145.2.8.5.1 PSE ~~PI~~ pair-to-pair ~~effective resistance and~~ current unbalance

145.3.8.10 PD pair-to-pair current unbalance

145A.1a Unbalance overview

Figure 145–22 — PSE current unbalance verification circuit

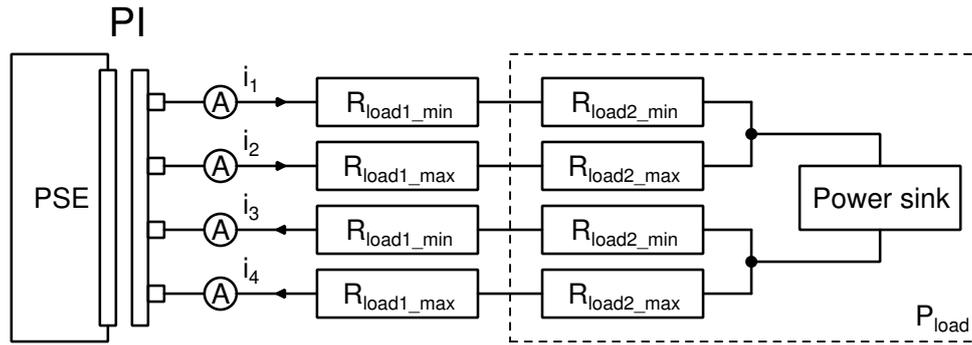
Figure 145–22 is a test fixture that is used in the PSE unbalance requirement. Because it was originally drawn for an Annex, it is too elaborate and shows parameters beyond the PI. It also contains a PD model, which is non-relevant for the PSE unbalance specification.

The equivalent Figure on the PD side is much better (Figure 145–31). Figure 145–22 is redrawn in the style of 145–31 and the PD specific details are abstracted away. The PD specification uses R_{source_min} and R_{source_max} as the test fixture parameters, for the PSE side we introduce R_{load1} and R_{load2} .

Replace Figure 145–22 as follows:

Replace the evaluation method on page 161 lines 22 to 32 by the following:

The evaluation method is as follows:

- Use R_{load_min} and R_{load_max} from Equation (145–16) and Equation (145–17) for low channel resistance conditions.
- Adjust the power sink such that P_{load} (the power consumed by the R_{load2} resistances and the power sink) equals P_{Class_PD} for the given Class
- Verify that i_1 , i_2 , i_3 , and i_4 are lower than $I_{Con-2P-usb}$, as defined in Table 145–16.
- Exchange R_{load_max} and R_{load_min} . Repeat steps b) and c).
- Repeat steps b) through d) for R_{load_min} and R_{load_max} from Equation (145–16) and Equation (145–17) for high channel resistance conditions.

Figure 145–31 — PD current unbalance verification circuit

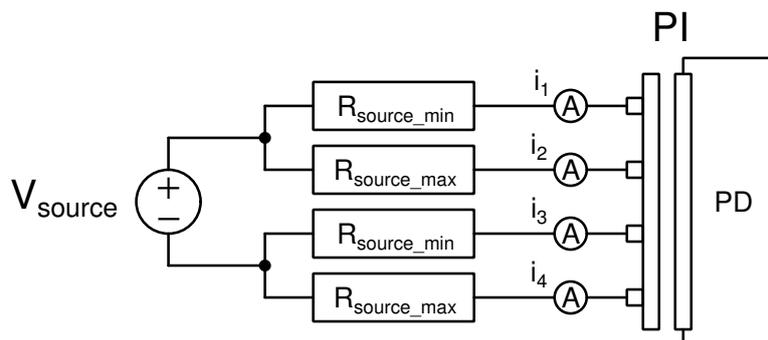
Replace Figure 145–31 as follows:

Figure 145A–0a — PD current unbalance verification circuit

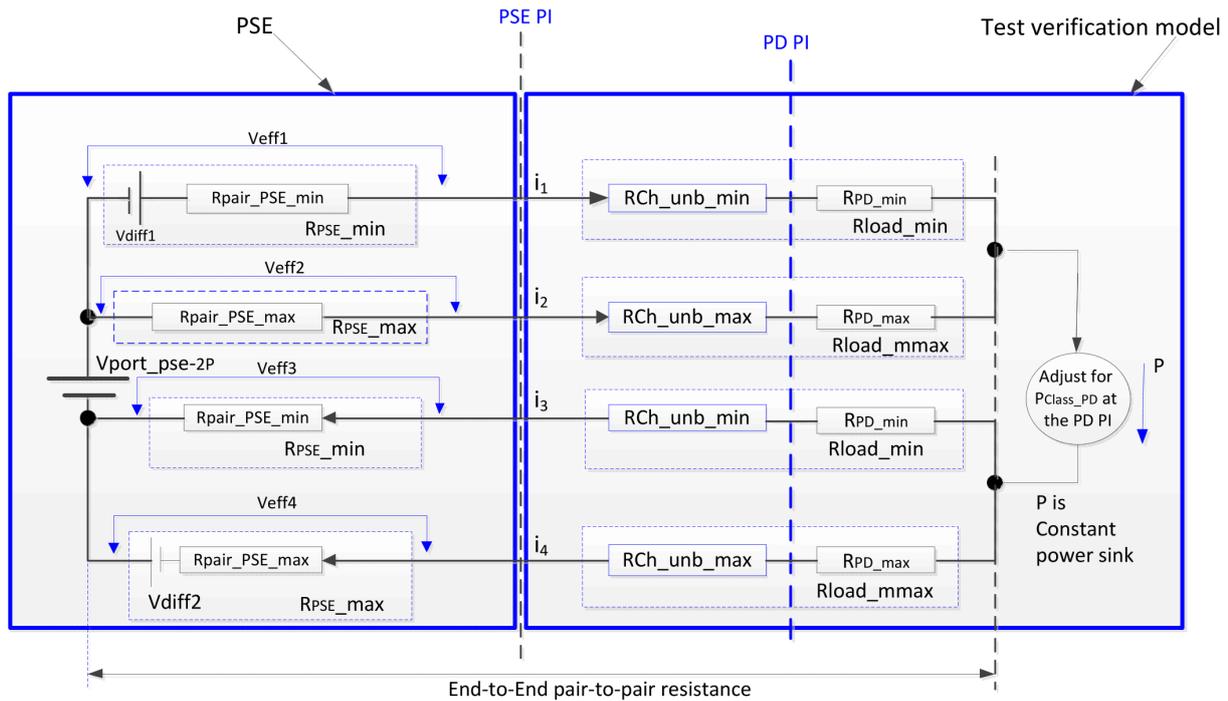
We still need a Figure that shows R_{PSE_min} and R_{PSE_max} as these parameters are referred to in the text. We can replace Figure 145A–1 with something that shows all.

Pair-to-pair current unbalance is caused by unequal resistances in a parallel current path of the same polarity. The PSE, the PD, and the link section connecting those independently contribute to unbalance. A system model for the worst-case instance of this is shown in Figure 145A–0a.

R_{PSE_min} or R_{PSE_max} common mode effective resistance is the resistance of the two internal conductors (including the internal components on each conductor) in a powered pair of the same polarity connected in parallel.

$R_{Ch_unb_min}$ and $R_{Ch_unb_max}$ are respectively the minimum and maximum common mode link section resistances in the powered pairs of the same polarity from the PSE PI to the PD PI per the model described in Figure 145A–1.

R_{PD_min} and R_{PD_max} are respectively the minimum and maximum common mode effective PD PI resistances. They account for the effective resistance of the resistive elements, combined with the PD pair-to-pair voltage difference and the effect of system end-to-end pair-to-pair unbalance.
